UNITED STATES ENVIRONMENTAL PROTECTION AGENCY

Re: Major Modification of the Federal TSCA PCB Chemical Waste Landfill Approval,
Wayne Disposal, Inc.; MID 048 090 633

Attachment: Excerpt from Major Modification Request, Figure 1, Proposed Master Cells VI-F and VI-G Layout

Figure 1. Proposed Master Cells VI-F and VI-G Layout

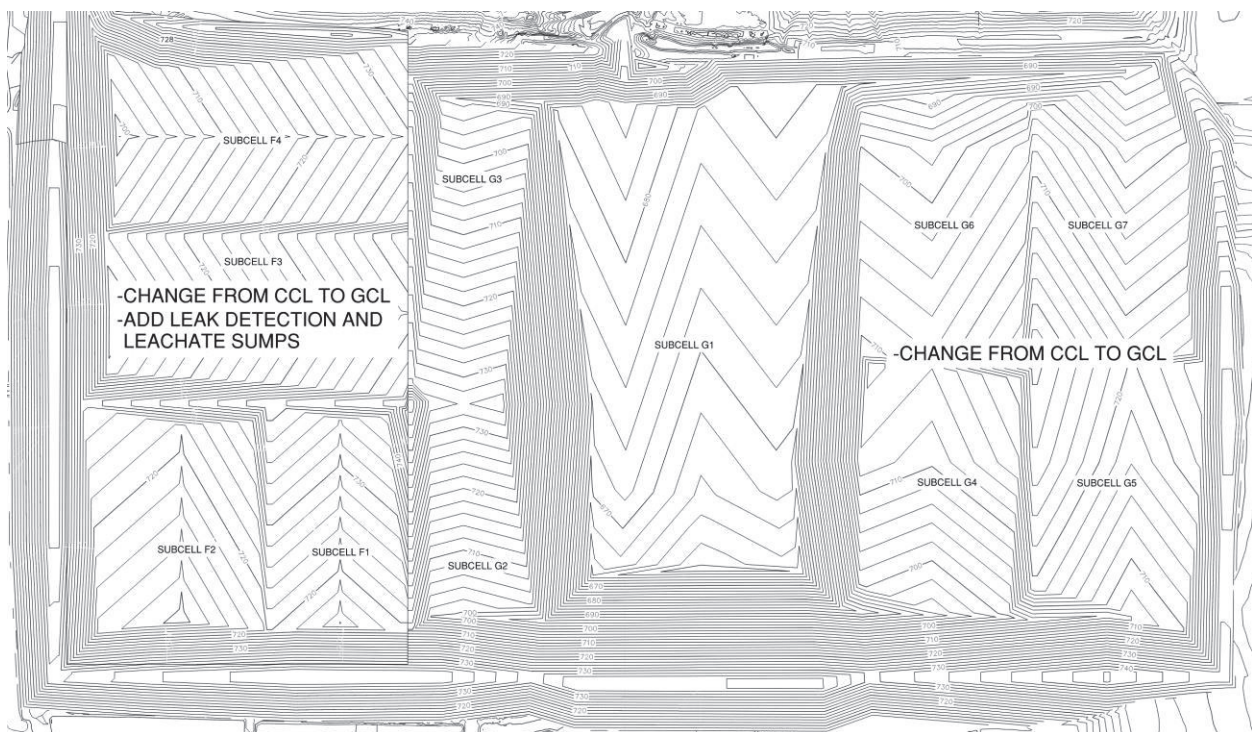
- GCL has superior resistance to freeze-thaw damage and is preferred considering Michigan's climate
- GCL has superior resistance to settlement-induced tensioning
- GCL reduces the need for compaction and is more consistent in achieving the approved grades
- GCL has substantially lower hydraulic conductivity

Figure 1 outlines the proposed area of the base liner system upgrade from CCL to GCL in MC VI-F and MC VI-G, as well as associated changes to the baseliner grades and layout of MC VI-F.

This letter serves as an approval of a major modification to the TSCA PCB Chemical Waste Landfill February 14, 2019 Approval. Based on this approval, the engineering design

description, drawings, and technical specifications for MC VI-G and MC VI-F in the January 21, 2021 major modification request and the July 16, 2021 liner grade revisions shall replace those in the March 29, 2018, Renewal Application for the WDI TSCA PCB chemical waste landfill that are referenced in the existing 2019 Approval.
